WESTINGHOUSE NUCLEAR SAFETY
SAFETY EVALUATION CHECK LIST

- 1) NUCLEAR PLANT(S) : BYRON/BRAIDWOOD UNITS 1 & 2
- 2) SUBJECT (TITLE): RELAXATION OF MSSV SETPOINT TOLERANCE TO +/-3%

BYRON/BRAIDWOOD UNITS 1 AND 2
INCREASED MAIN STEAM SAFETY VALVE SETPOINT TOLERANCE
SAFETY EVALUATION

FIGURE 15.2-4

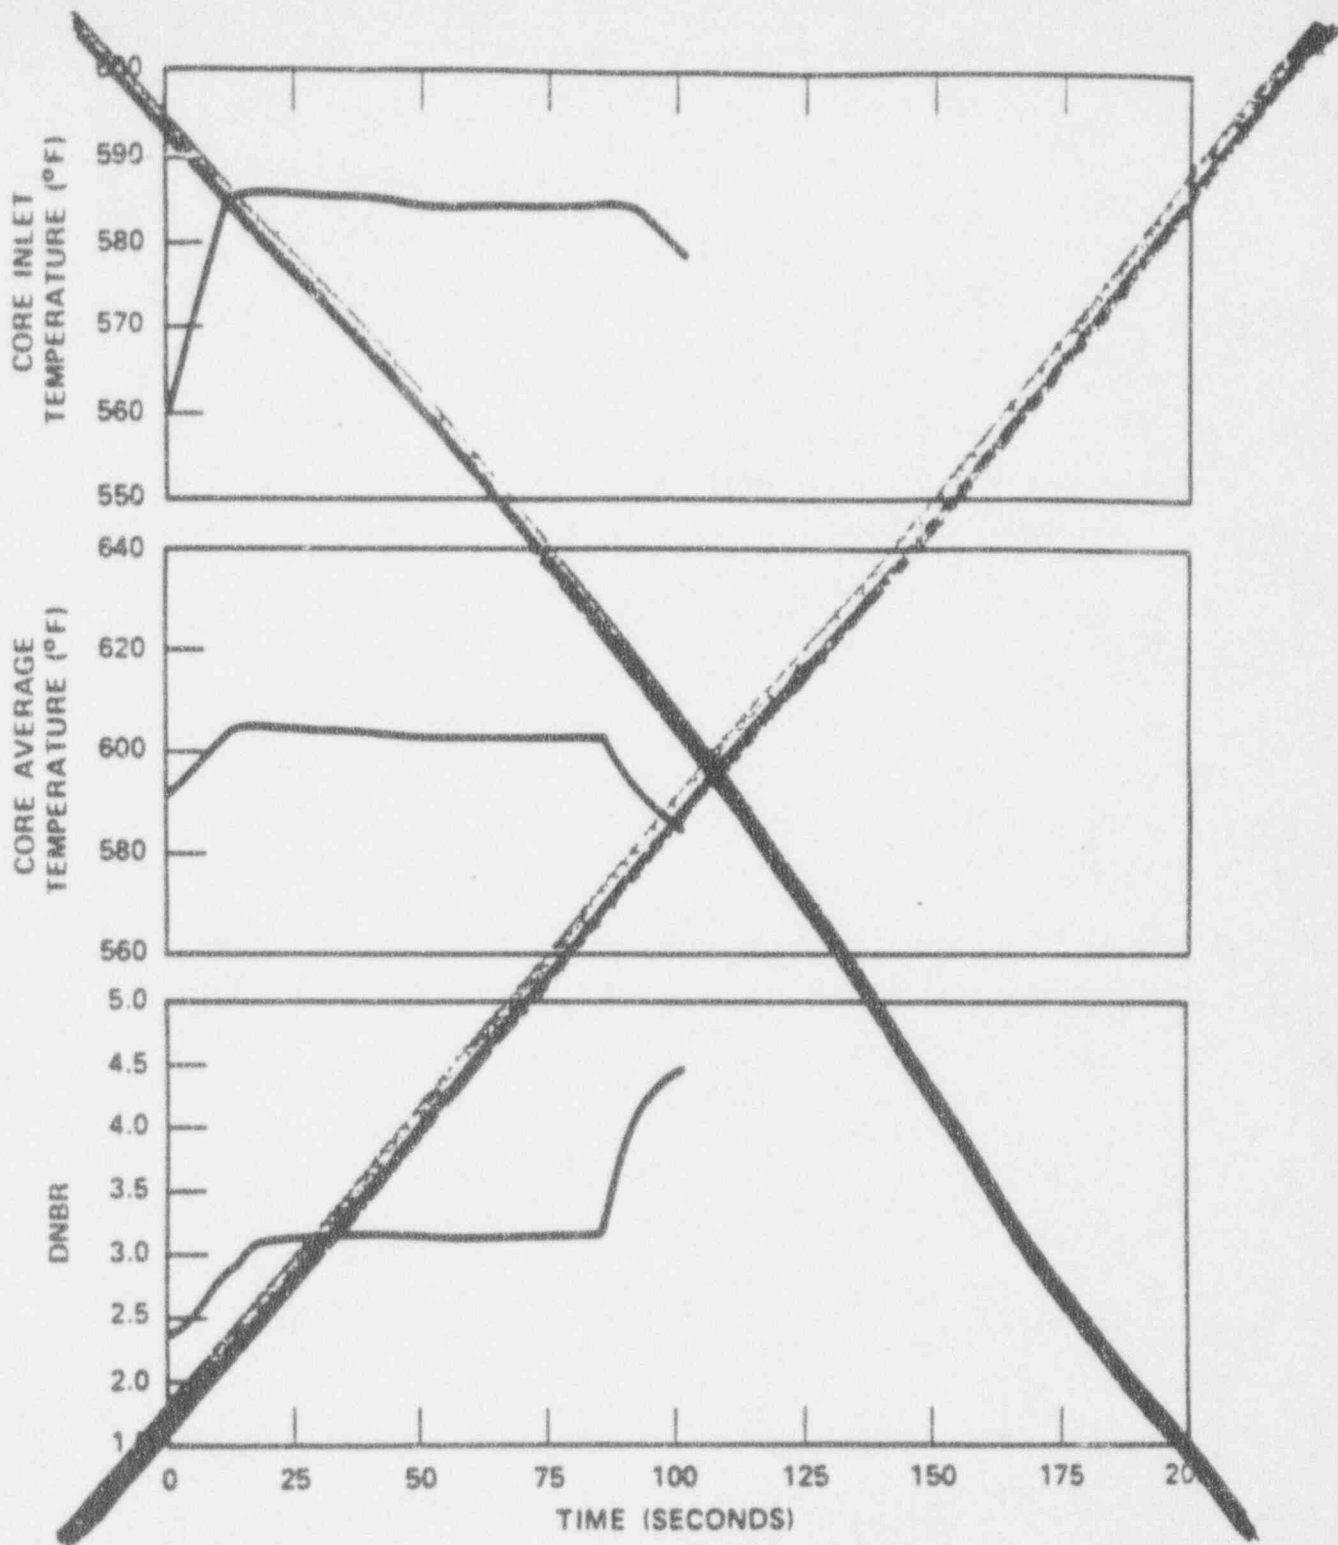
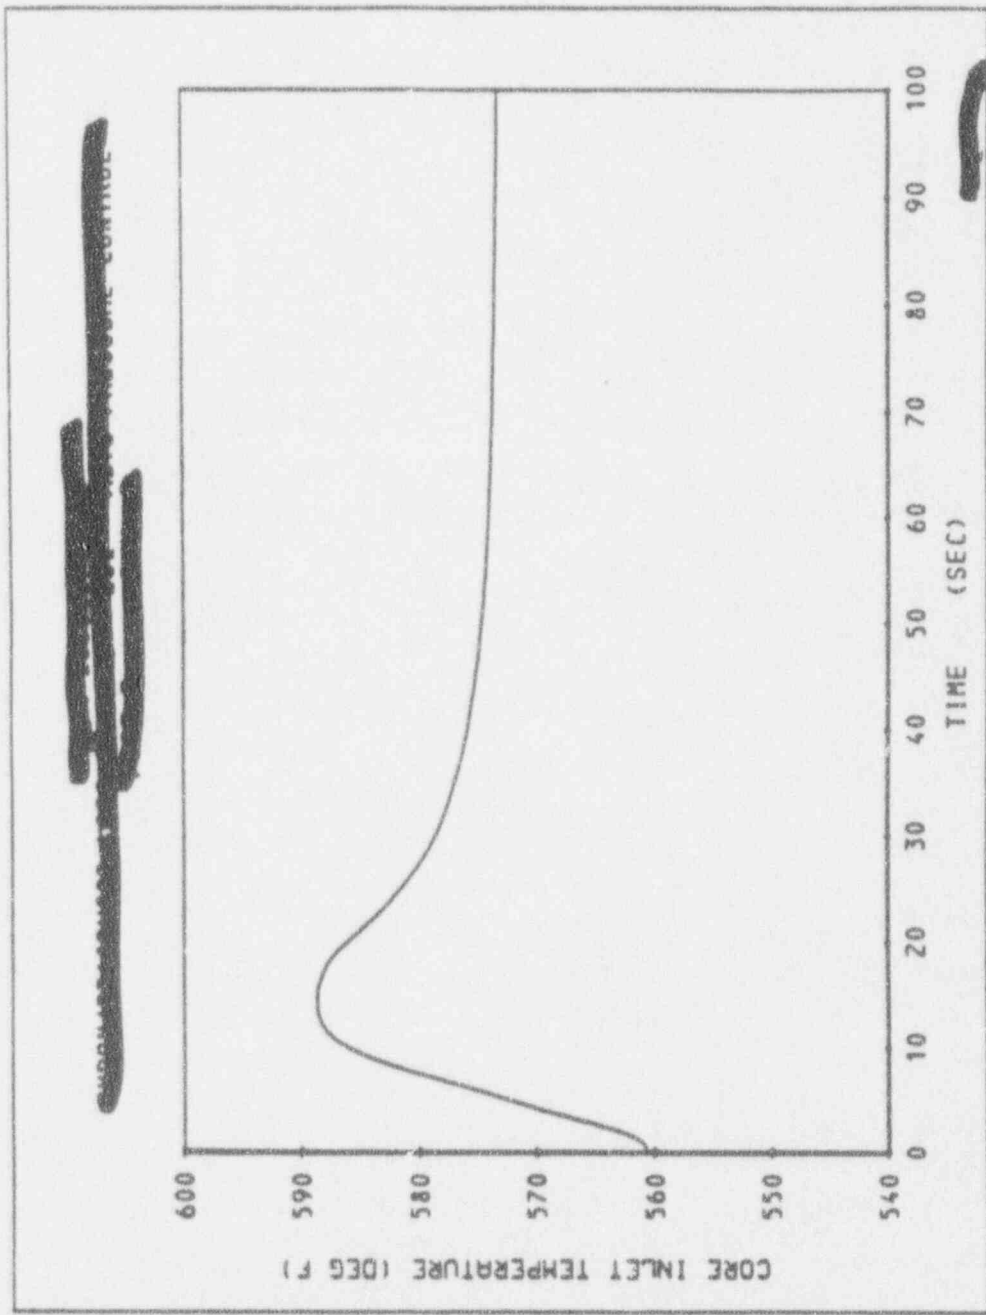
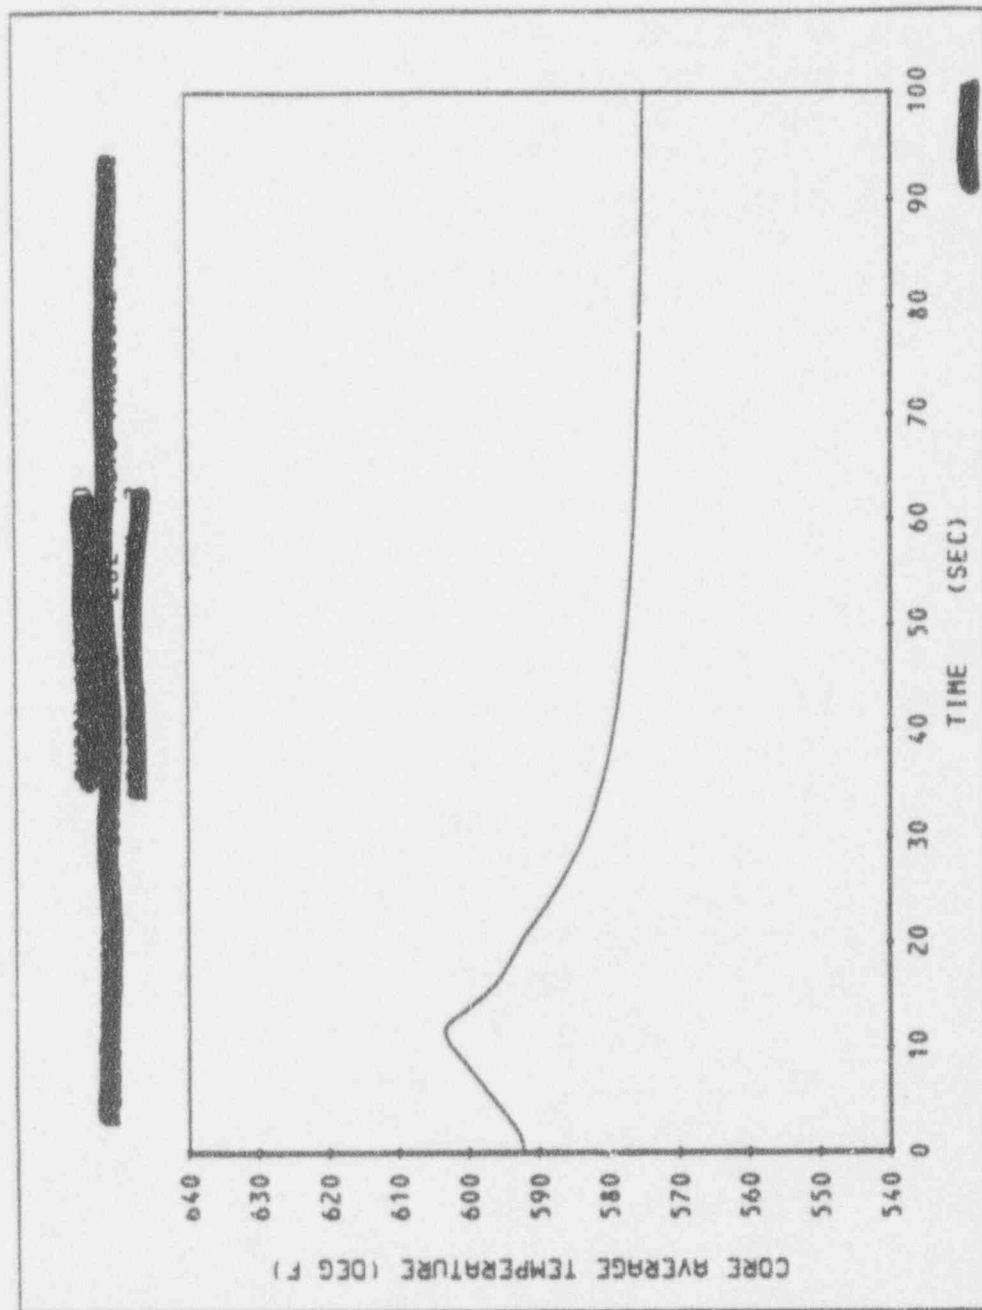
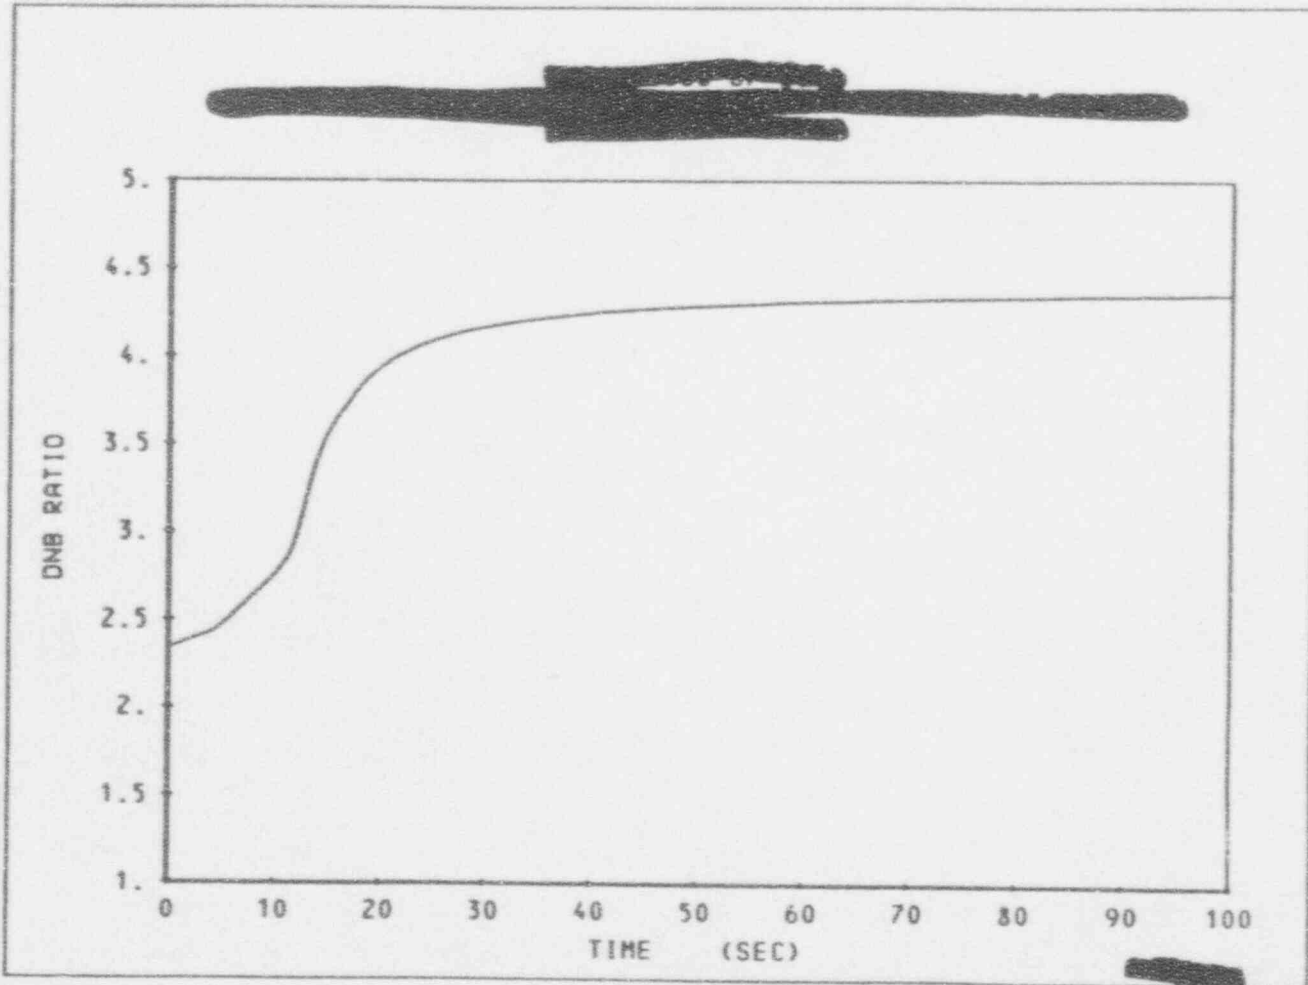
Figures 15.2-3 and 15.2-4 show the response for the total loss of steam load with a large negative moderator temperature coefficient. All other plant parameters are the same as the above. The DNBR increases throughout the transient and never drops below its initial value. Pressurizer relief valves and steam generator

REPLACE WITH
the following
Figures
